NEDO-21061

NRC QUESTIONS DATED JUNE 30, 1978, WITH RESPONSES

APPENDIX A-3

Revision 3 6/78

Figure 1

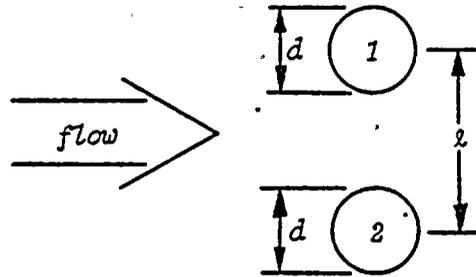
The DFER (NEDO-21061) methodology for estimating steady state drag loads on submerged structures is unacceptable for those cases where the structures represent significant blockage to the pool water slug motion. We require that the drag coefficients used to compute the loads be modified according to traditional literature references which take account of the effect of blockage.

Structures such as the bracing that support downcomer vents experience drag loads as a result of the pool water slug motion. The distance between bracing pipes ranges from virtually touching to far apart. The bracing lies in a plane perpendicular to the pool slug motion, i.e., an orientation known in the literature as a side-by-side configuration. The drag coefficients,  $C_d$ , for this condition can be analyzed by considering the idealized case of two cylinders located side by side (see Figure 1).

For values of  $l >$  approximately  $3d$ , the literature shows no interference effects, and the drag is accurately predicted by considering the cylinders independently of each other. For values of  $l$  less than approximately  $3d$ , the effects of the shear layer interaction between the lower boundary layer of #1 with the upper boundary layer of #2 results in a lowering of the values of  $C_D$  (see Figure 1). When  $l = d$  (or when the cylinders touch); the  $C_D$  can be estimated as that of a flat plate of length  $2d$ .

## (i) Case 1 (Figure 1):

- For  $\lambda \geq 3d$ , use steady-state  $C_D$  as before.
- For  $1.1d \leq \lambda < 3d$ , use steady-state  $C_D$  as before.
- For  $\lambda < 1.1d$ , use steady-state  $C_D$  for a flat plate of width  $2d$  normal to flow.

Figure 1. Pool Surface Elevation, Run 36

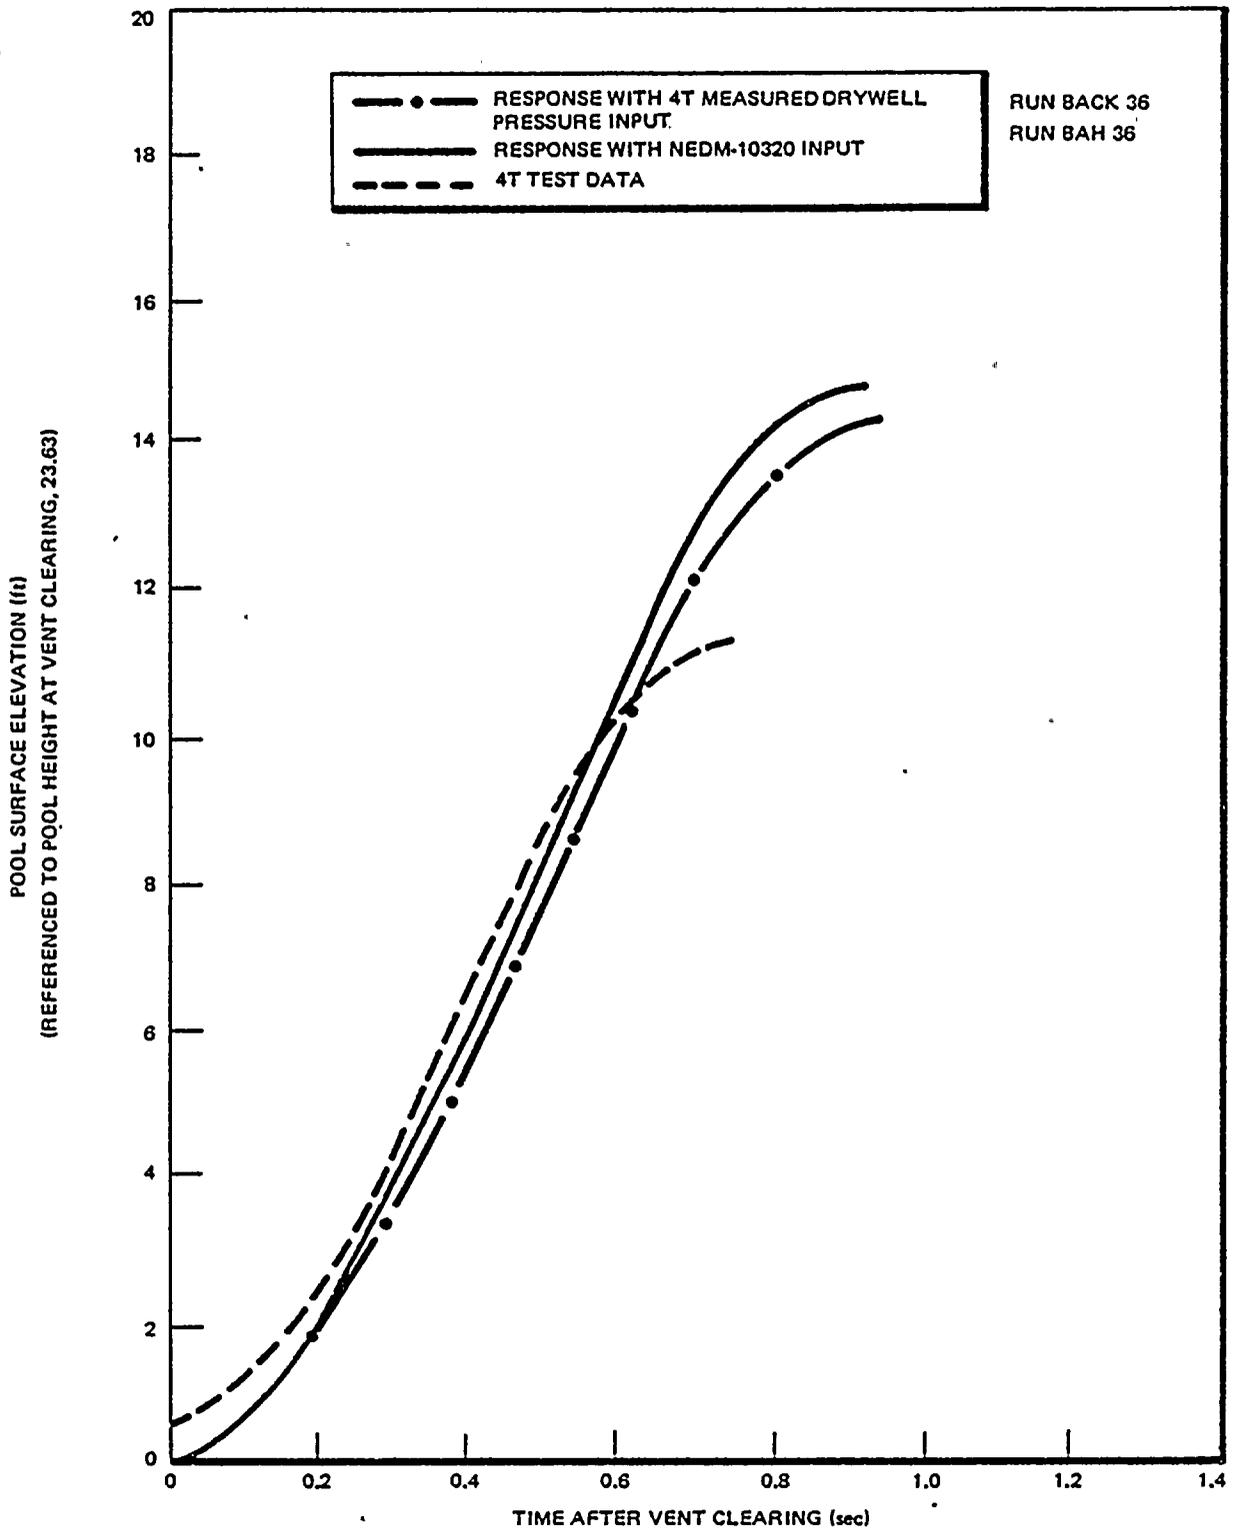
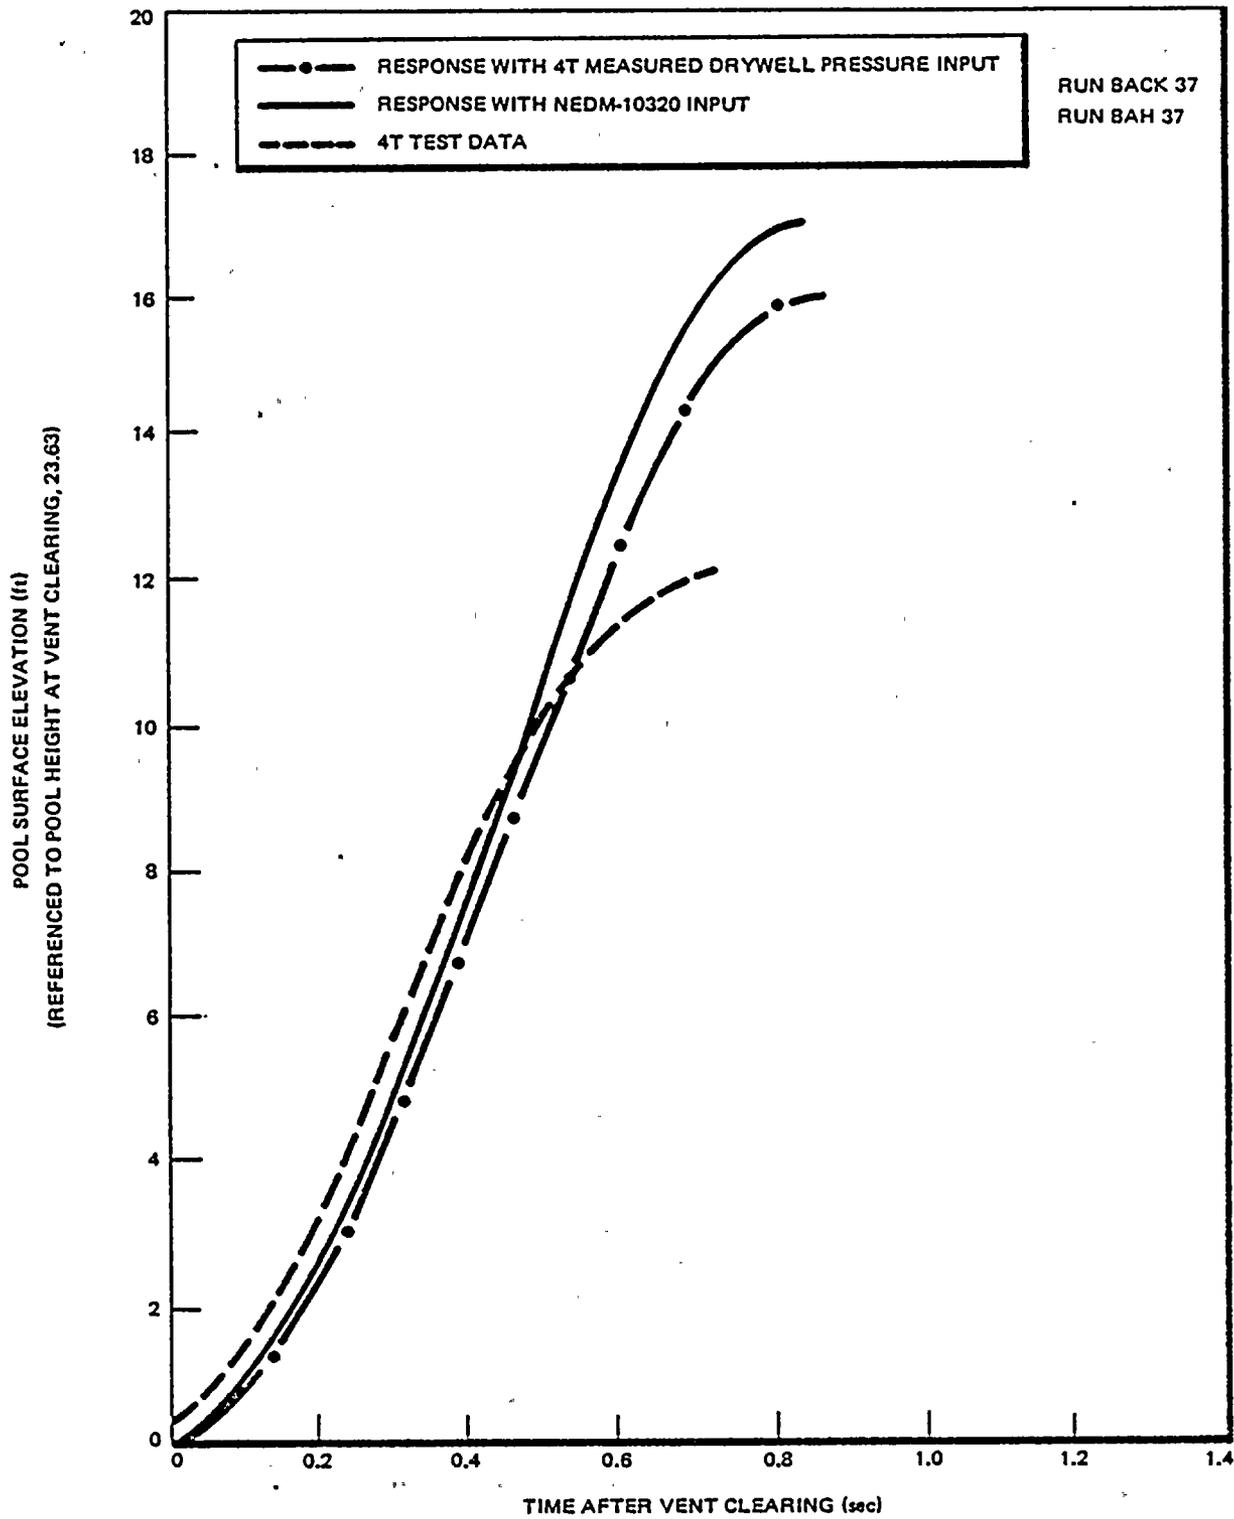
In the response to NRC questions M020.58(4) (NRC questions dated January 14, 1977) it is stated that "Calculations of pool swell for Mark II containments using the analytical model utilize the appropriate calculated drywell pressure response (NEDM-10320) as an input." It is our position that the specification of pressure history is an essential element of the DFFR methodology and that the particular choice cited above has not been demonstrated to be appropriate.

To justify such use, we require that pool swell calculations be made for selected 4T tests using drywell pressure response computed according to NEDM-10320 in lieu of the measured drywell pressure histories. The selected 4T tests are the two saturated liquid blowdowns made during the phase II test series (Runs 36 and 37). The response (pool swell elevation, velocity, bubble pressure) calculated in this manner should be compared with measured values and with similar calculations made using the measured drywell pressure histories.

The pool surface elevation curves (Figures 1 and 2) show that results using NEDM-10320 drywell pressures yield pool swell elevations which exceed the measured 4T test data, and also exceed the results obtained using the 4T - measured drywell pressure.
